**RULE NO.: R161-23.18**

## **NOTICE OF RULE ADOPTION**

R161-23.18: Modifies the Standards Manual as follows:

STANDARD NO.  
**SPD 660-3**

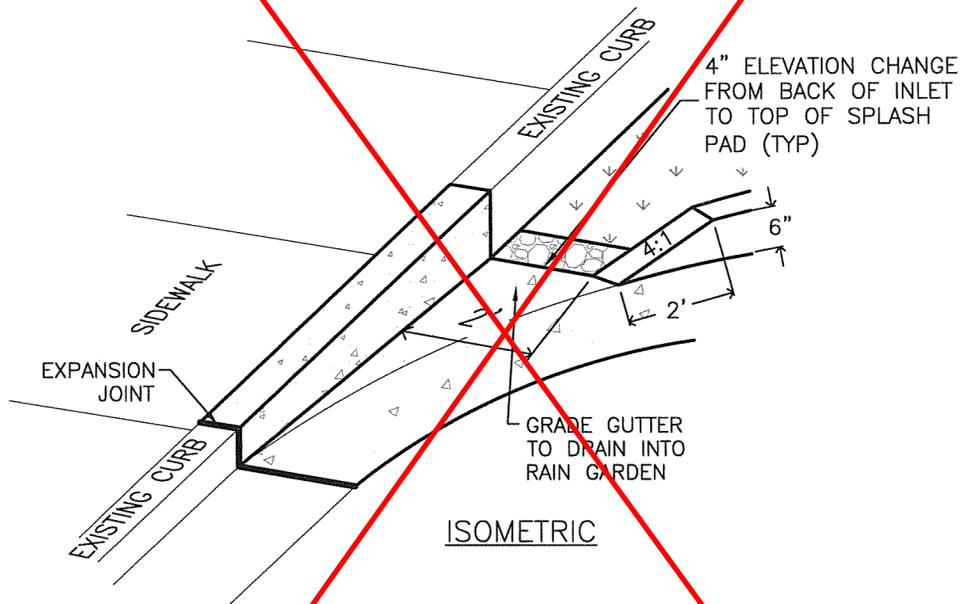
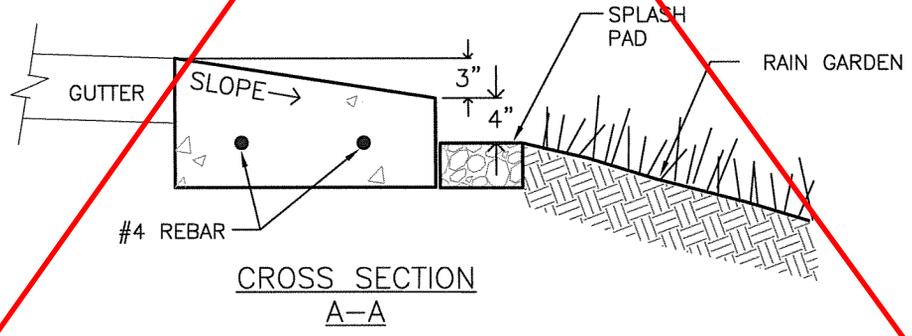
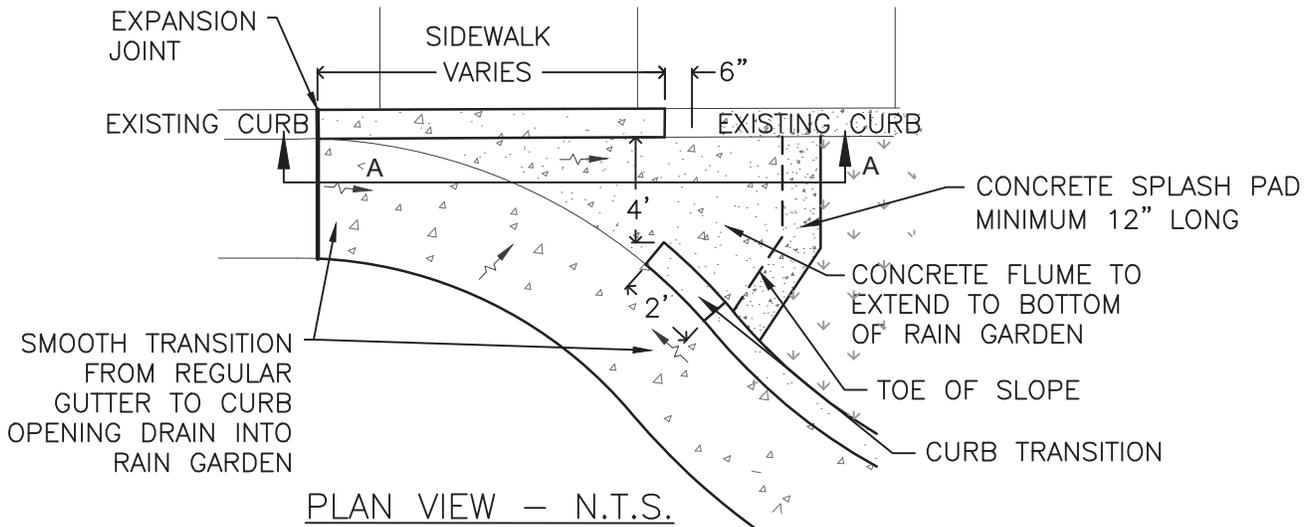
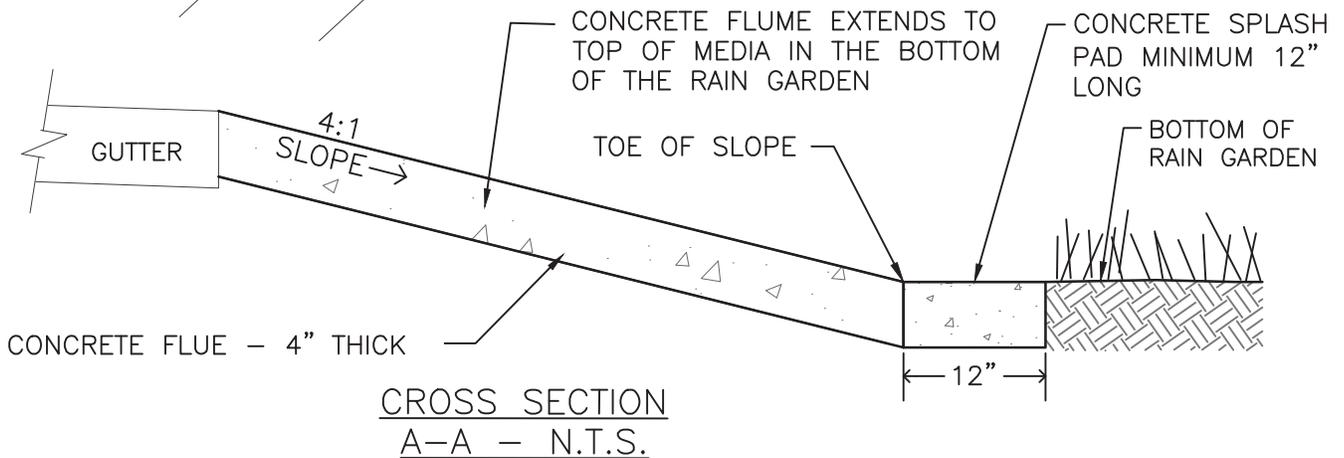
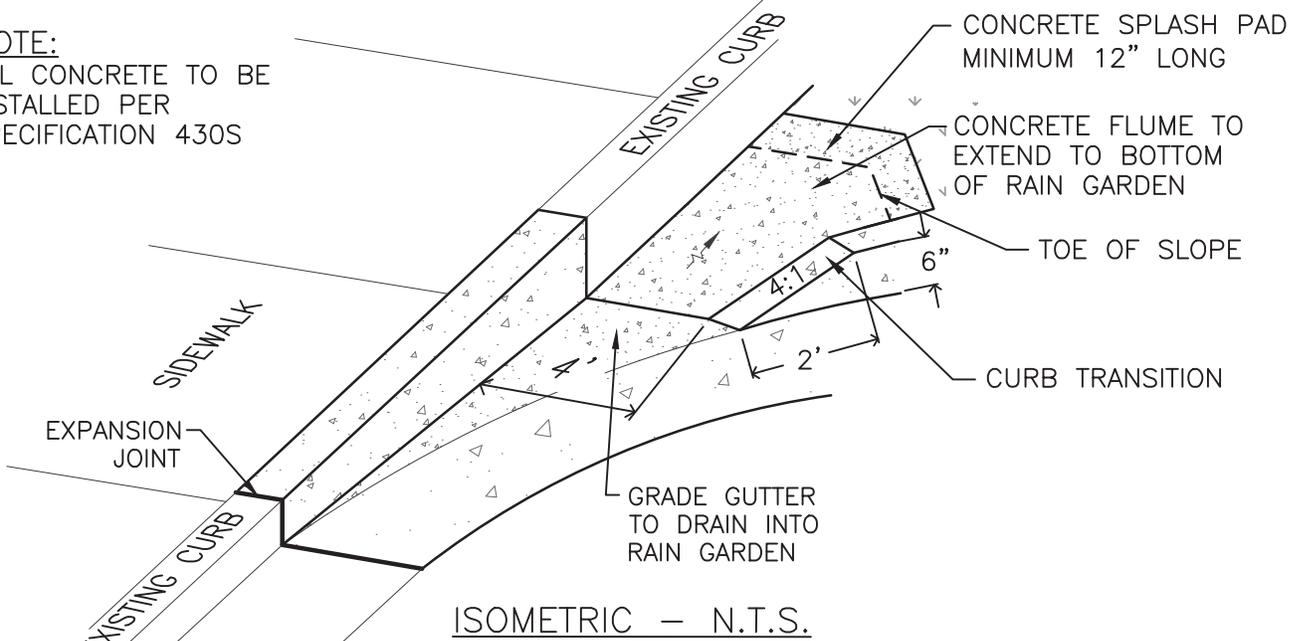
- SPD 660-3, Rain Garden Typical Inlet Detail 1 Proposed changes to rain garden in the right of way details include removing the rip rap or flagstone splash pad and replacing this requirement with a concrete splash pad.
- SPD 660-4, Rain Garden Typical Inlet Detail 2 The width of the rain garden inlet was expanded from two feet to four feet.
- These modifications were necessary to ensure that stormwater is conveyed into the rain garden for treatment. The rock rip rap and flagstone splashpads were causing sediment to build up, blocking flows from entering the rain garden for treatment.
